4-1 – 12

402 (New), 402.1 (New)

Proponent: Kim Paarlberg, International Code Council

403.5, Figure 403.5, 403.5.1, Figure 403.5.1(c) (New), 403.5.2

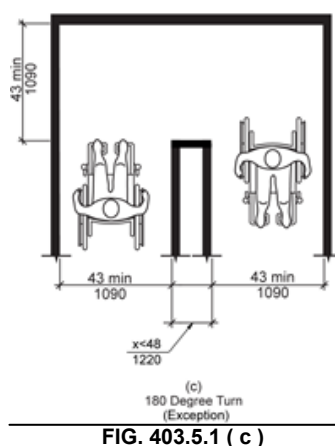
403.5.1 Clear Width at 180 Degree Turn Around Object. Where an accessible route makes a 180 degree turn around an object that is less than 48 inches (1220 mm) in width, clear widths shall be 42 inches (1065 mm) minimum approaching the turn, 48 inches (1220 mm) minimum during the turn, and 42 inches (1065 mm) minimum leaving the turn.

1. Section 403.5.1 shall not apply where the clear width during the turn is 60 inches (1525 mm) minimum.
2. Section 403.5.1 shall not apply where a minimum clear width of 43 inches (1090 mm) is provided approaching, during, and leaving the turn.

A new exception is proposed for the 180-degree turns, based on an analysis also completed for the Anthropometry of Wheeled Mobility report. The analysis suggested that 95% of manual wheelchair users, as well as 95% of power chair and scooter users could accomplish a turn around a barrier when all three sides of the turn were 43 inches (Steinfeld, et al., 2010, pg. 166).

FIG. 404.2.2
CLEAR WIDTH OF DOORWAYS

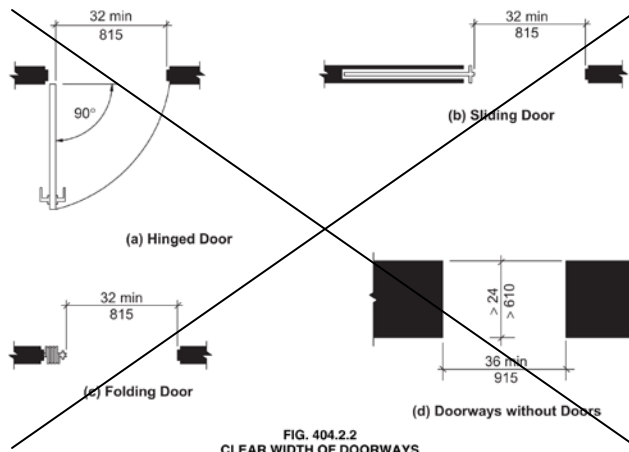
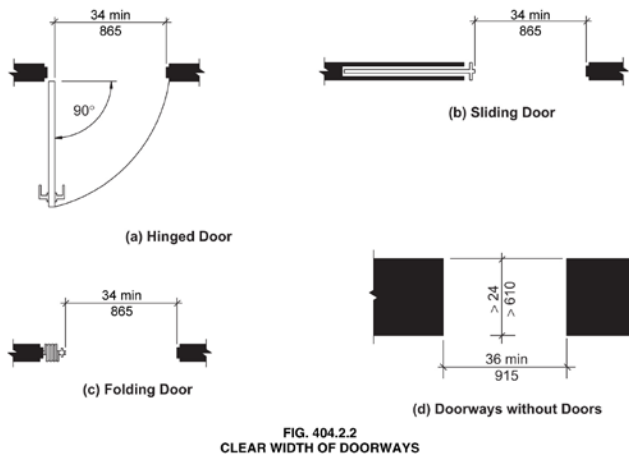
404.2.2 Clear Width. Doorways shall have a clear opening width of ~~32~~ **34** inches (~~815~~ **865** mm) minimum. Clear opening width of doorways with swinging doors shall be measured between the face of door and stop, with the door open 90 degrees. Openings more than 24 inches (610 mm) in depth at doors and doorways without doors shall provide a clear opening width of 36 inches (915 mm) minimum. There shall be no projections into the clear opening width lower than 34 inches (865 mm) above the floor. Projections into the clear opening width between 34 inches (865mm) and 80 inches (2030 mm) above the floor shall not exceed 4 inches (100 mm).

The following is Figure 404.2.3.2(e) from the A117.1-2009 standard.

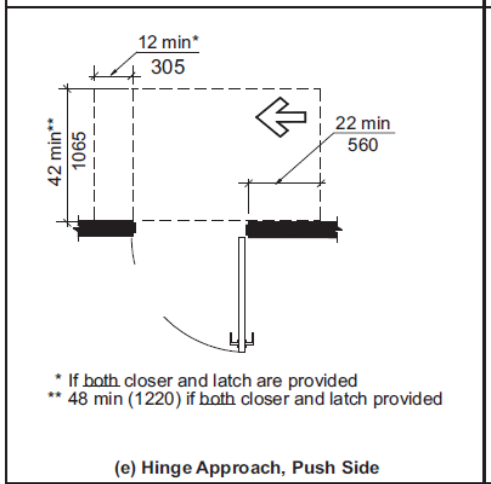
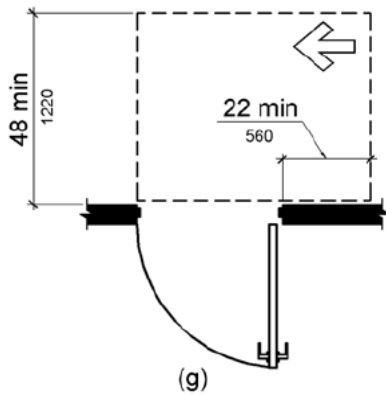
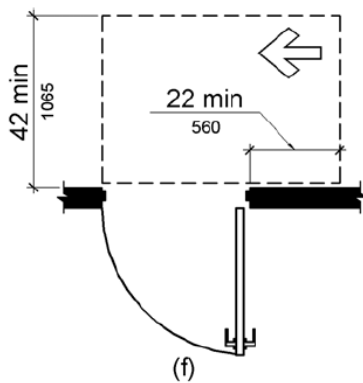
The A117.1 requires there 12 inches beyond the latch side on this door if both a closer and a latch are provided on the door. The ADA does not have this 12 inch requirement.

This requirement was added to the A117.1 standard between the 1998 and 2003 editions by proposal 4-015 and was modified by public comment that cleaned up the footnote reference for it. The proponent's reason statement said that figure (b) the front approach push side and figure (e) the hinge approach push side are similar situations and that having the 12 inches on the forward approach should also be provided on the hinge approach.

Because this extra requirement creates a discrepancy between the A117.1 and ADA which is not readily apparent and well known, the elimination of the footnote reference would help to coordinate the two standards and make this basic issue of door maneuvering clearances consistent. It seems that the addition of this requirement was probably not well justified when it was added into the 2003 A117.1 standard and with the change made in Section 404.2.3 of the 2009 edition which prevented door maneuvering clearances from including knee and toe clearance it made the difference between the A117.1 and the federal requirements that much greater. With some of the task groups looking at changing the 'building blocks' which could further affect maneuvering clearances, it would seem that this difference between the two standards should be eliminated or better justification should be provided so that it could be added into the federal requirements and coordinated that way.

The graphic representations of the various layouts are provided to better illustrate the differences. In the 2009 standard it is Fig 404.2.3.2(e) and in the 2010 ADA it is Figure 404.2.4.1(g). See ADA figure 404.2.4.1(f) for base condition.

FIG. 404.2.3.3
MANEUVERING CLEARANCE AT SLIDING AND FOLDING DOORS

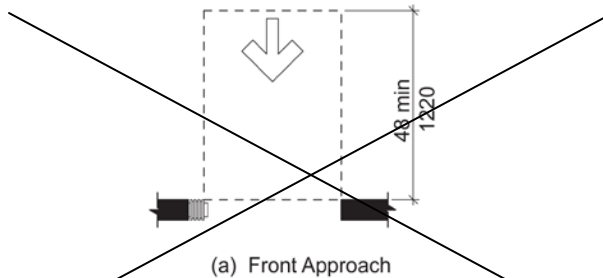
Table 404.2.3.2 – Maneuvering Clearances at Sliding and Folding Doors

TABLE 404.2.3.4 - MANEUVERING CLEARANCES FOR DOORWAYS WITHOUT DOORS

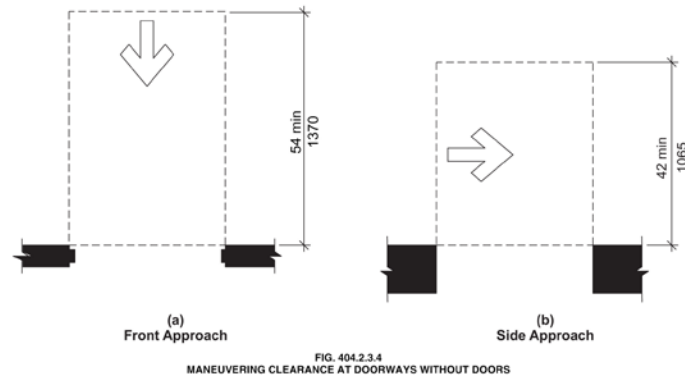
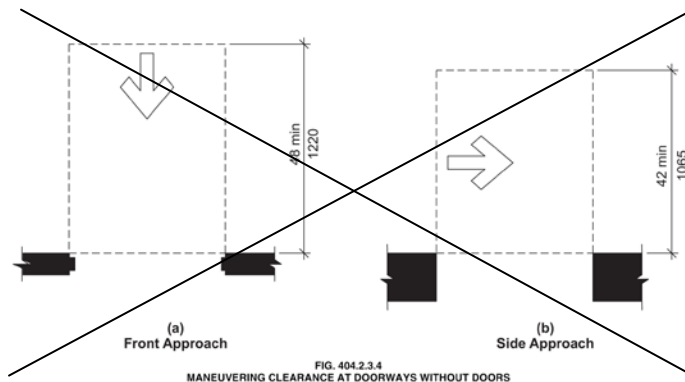
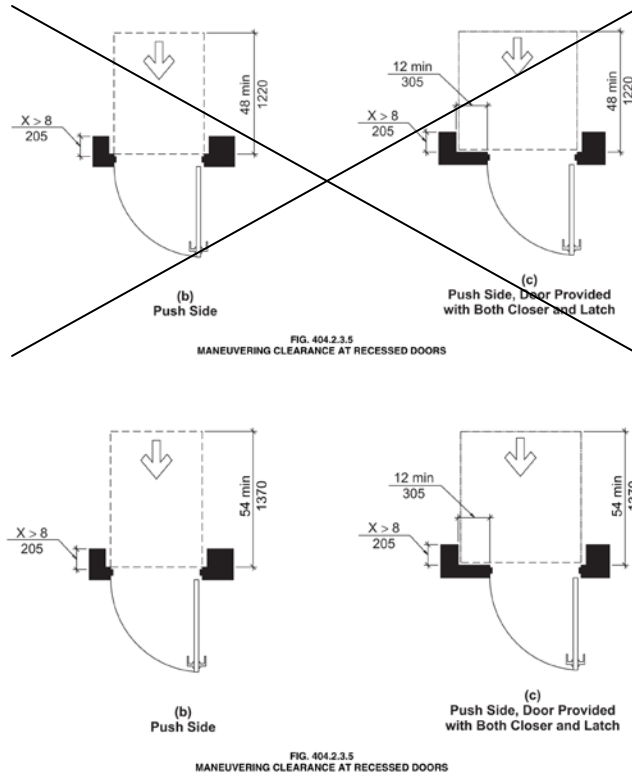
Approach direction	MINIMUM MANEUVERING CLEARANCES Perpendicular to Doorway
From front	48 54 inches (1220 1370 mm)
From side	42 inches (1065 mm)

Delete and substitute Figure as follows:

FIG. 404.2.3.5
MANEUVERING CLEARANCE AT RECESSED DOORS

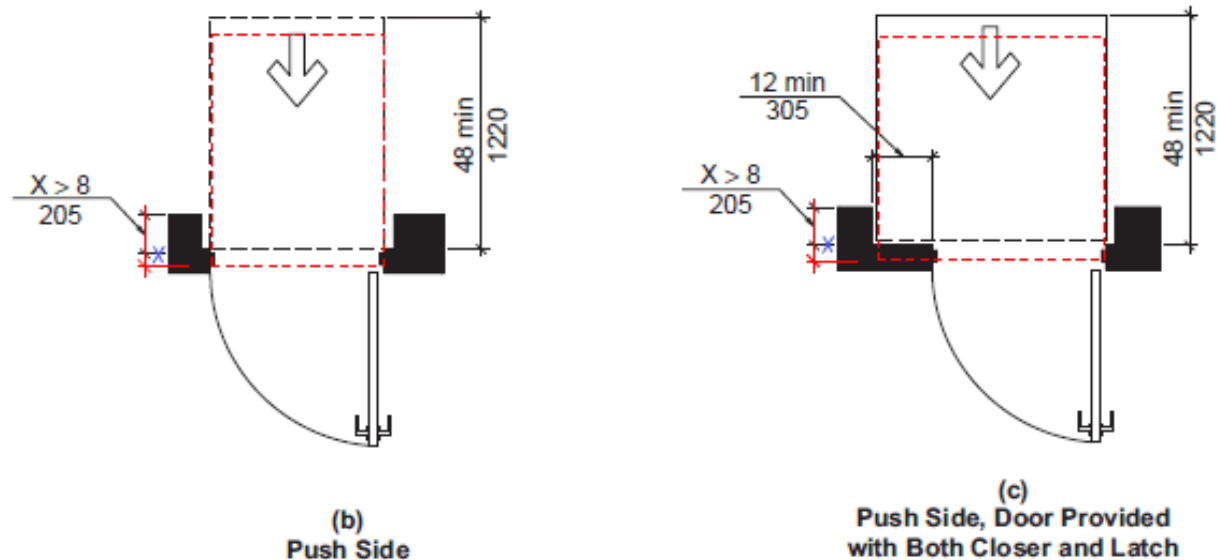
Door recess drawings are not correct. The text indicates that the recess is to be measured from the face of the door but the figures show in two cases the recess measured from the face of the frame.

Reason: When the door is in a frame and the door swings toward you, the face of the door is typically the same as the closest edge of the frame. However, when the door swings away from you, it is on the far side of the frame and the nearest face of the door is already recessed from the edge of the frame. The modified Figure shows the proper method. Although not shown, obviously the 48 inch dimension would need to be revised to show the distance from the face of the maneuvering space to its perpendicular extent.

The revision would show the correct method for assessing recess. This has caused a number of incorrect applications and resulted in doors often being located too far from the face of the adjoining wall.

(c)
Push Side, Door Provided
with Both Closer and Latch

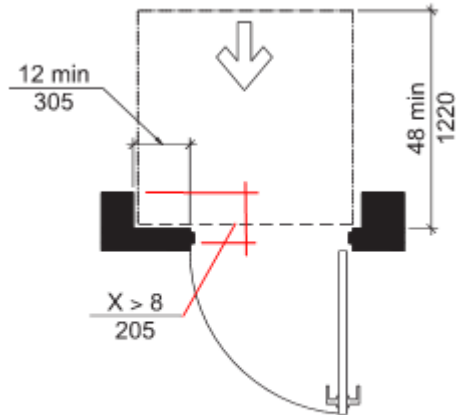
Relocate the arrows and call dimension for the 8 inch depth from the left side of the figure to the location shown below.

Reason: The text for this section states that the dimension is to the "face of the door" measured perpendicular to the "face of the door". The Figure shows the 8" recess from the face of the wall of the door.

Fig. 404.2.5
TWO DOORS IN A SERIES

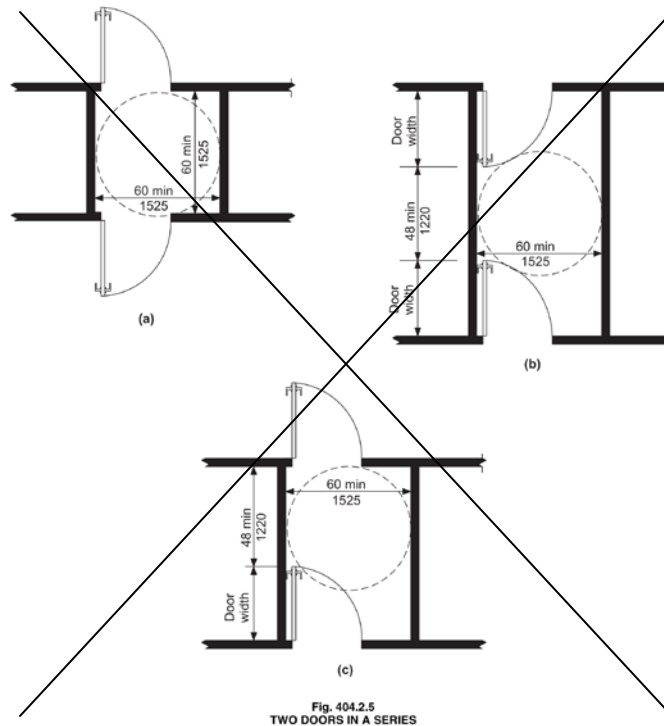
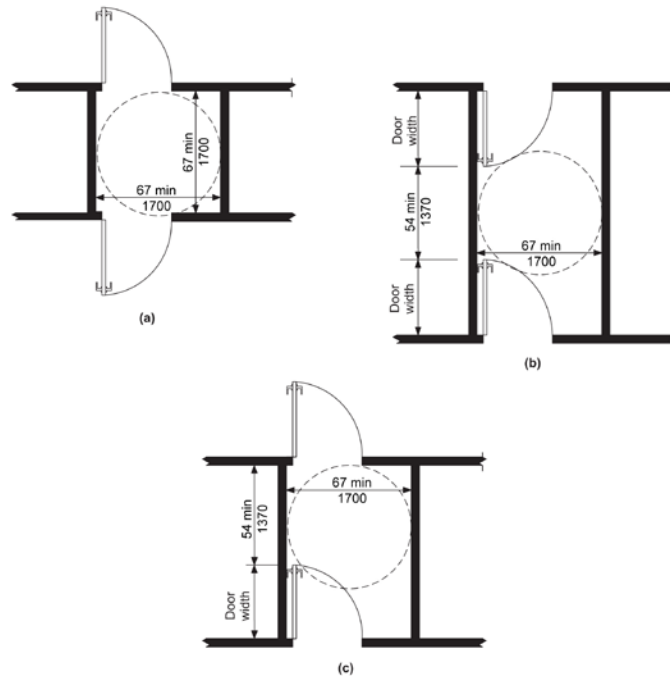
404.2.5 Two Doors in a Series. Distance between two hinged or pivoted doors in series shall be ~~48~~ **54** inches (~~1220~~ **1370** mm) minimum plus the width of any door swinging into the space. The space between the doors shall provide a turning space complying with Section 304.
